Product Change Notification

PCN-PCC-264-2017

| Business Unit | Product Line Code | Type of Change | Action | Date of Issue |
|----------------------|-------------------|-----------------------------|-------------------------------|---------------|
| PCC - PCB Connectors | AAC | Product Change Notification | Notify Distributors and Field | 2/6/2017 |

Description for Product Change Notification

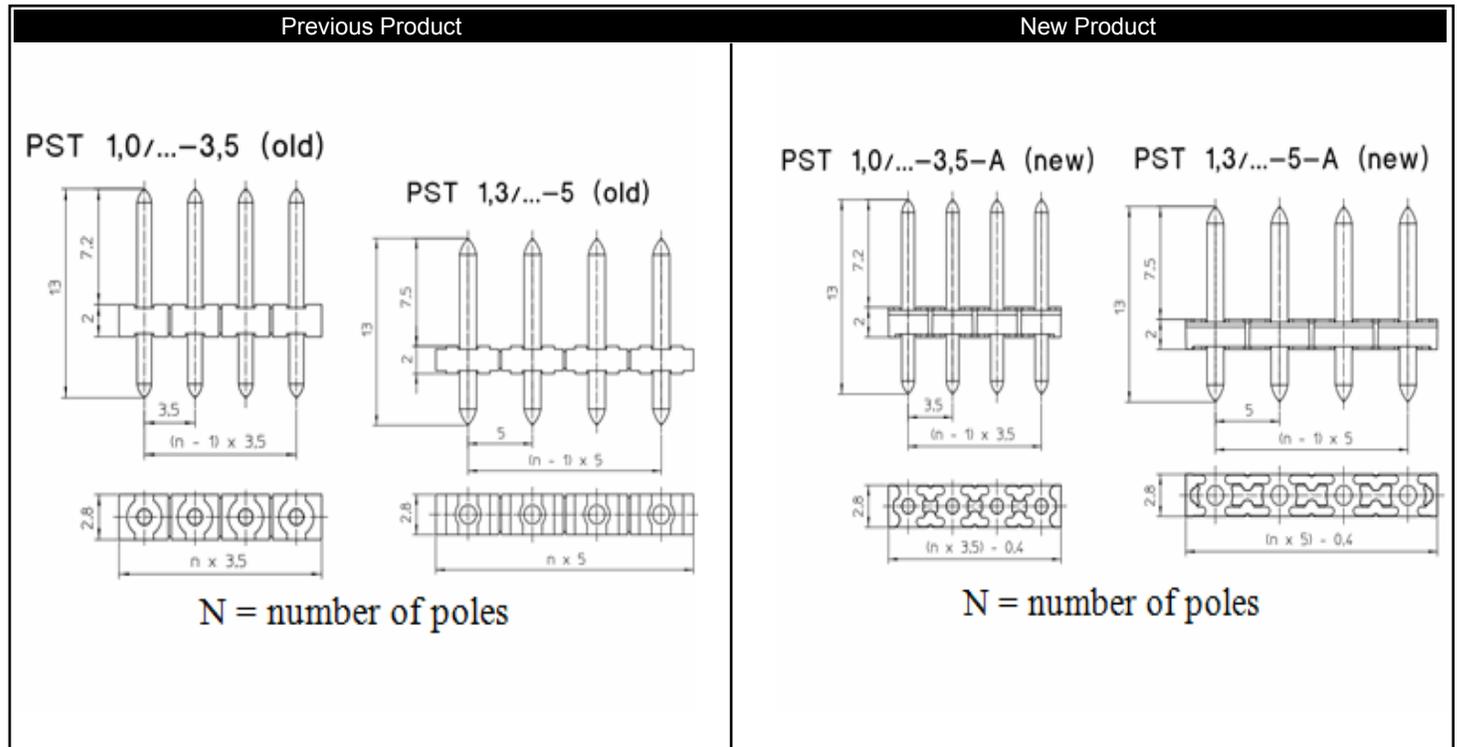
PST strips can be stacked together without going out of pitch. The current separation process of pin strips (to create the correct pole number) will be changed to a molding process which delivers the right pole number directly. The pin strip design and overall length will change. All other outer dimensions and the technical data remain the same. The following part numbers have also been affected: 1944330 1988590 1705406 1970294 1944534 1988600 1944547 1988613 1987148 1988626 1945326 1945478 1726305 1988639 1945339 1987151 1988642 1945342 1726282 1988655 1945355 1988697 1725979 1988707 1988710 1988723 1763384 1988736 1988749
